QUALITY ASSURANCE -- NON-CONFORMANCE REPORT

Report No: NCR-000192

Reference Description: Unapproved base metal repair DP582

Job Name: SAS Superstructure

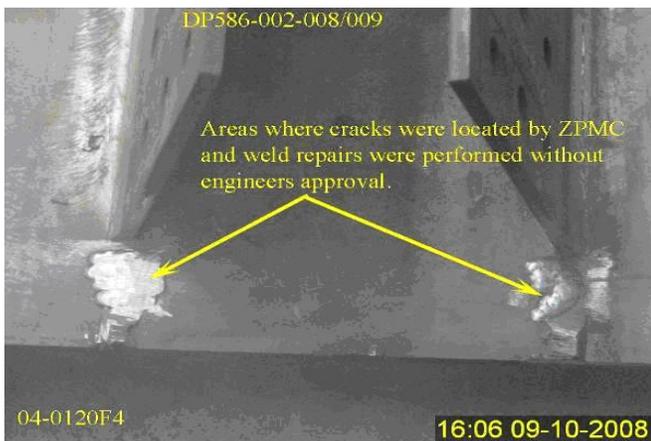
The Contractor performed unapproved weld repairs. The Contractor performed repairs of cracks in base metal without prior Engineer approval. It was noted that the Contractor's QC inspector was not recording the welding parameters during the repair. This was observed in base metal repairs to deck panel DP582-001 on cracks found at the ends of weld joint #'s -008 and -009.

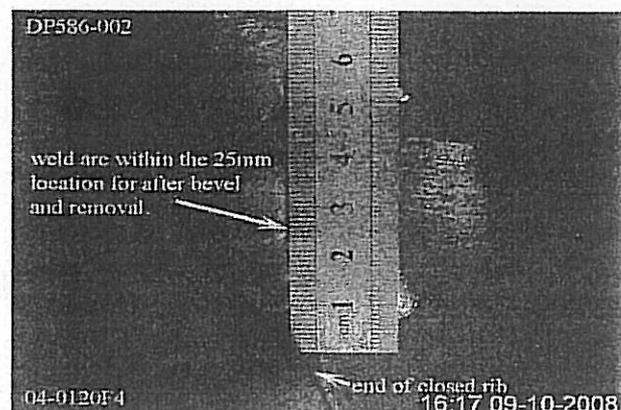
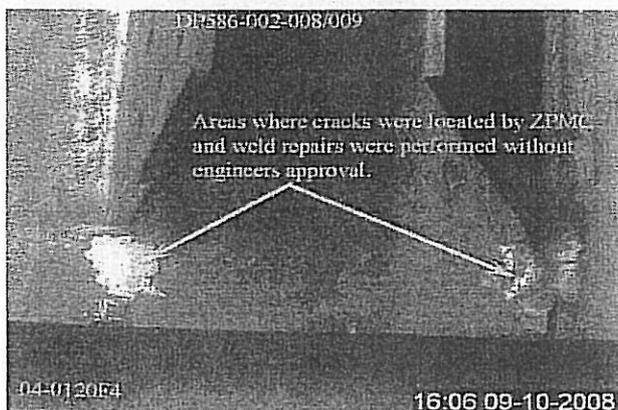
The Contractor performed unapproved weld repairs. The Contractor performed repairs of cracks in base metal without prior Engineer approval. It was noted that the Contractor's QC inspector was not recording the welding parameters during the repair. This was observed in base metal repairs to deck panel DP582-001 on cracks found at the ends of weld joint #'s -008 and -009.

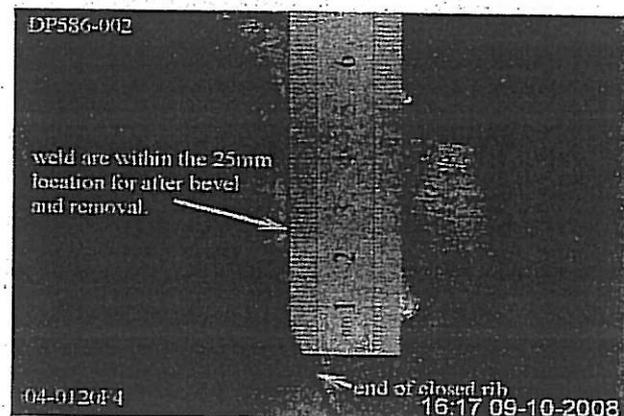
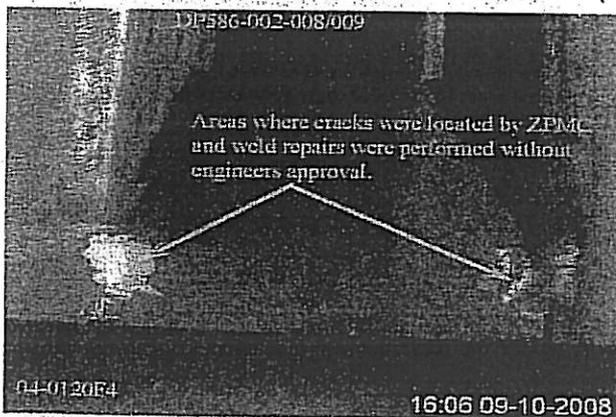
The Contractor performed unapproved weld repairs. The Contractor performed repairs of cracks in base metal without prior Engineer approval. It was noted that the Contractor's QC inspector was not recording the welding parameters during the repair. This was observed in base metal repairs to deck panel DP582-001 on cracks found at the ends of weld joint #'s -008 and -009.

探伤位置图
Scheme showing the test part

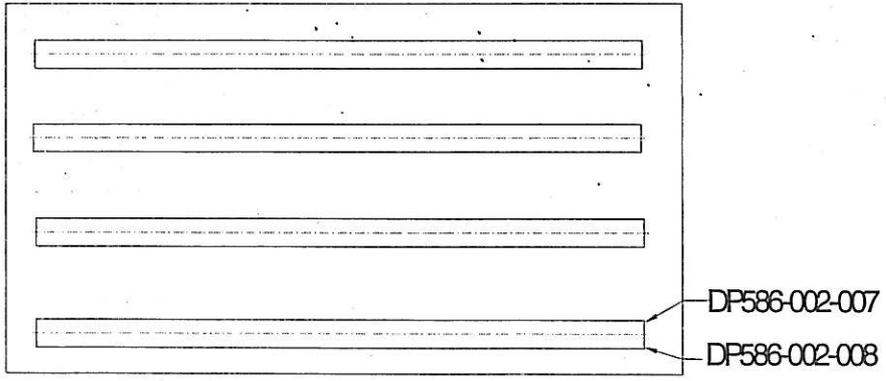
- 备注:
- 焊后
 - 校火后
 - WR/CWR 碳刨后
WR/CWR NO: _____
 - WR/CWR 返修后
WR/CWR NO: _____
 - SPCM
 - 其它 *After repair*
- 焊接方法: FCW
- 车间位置: _____
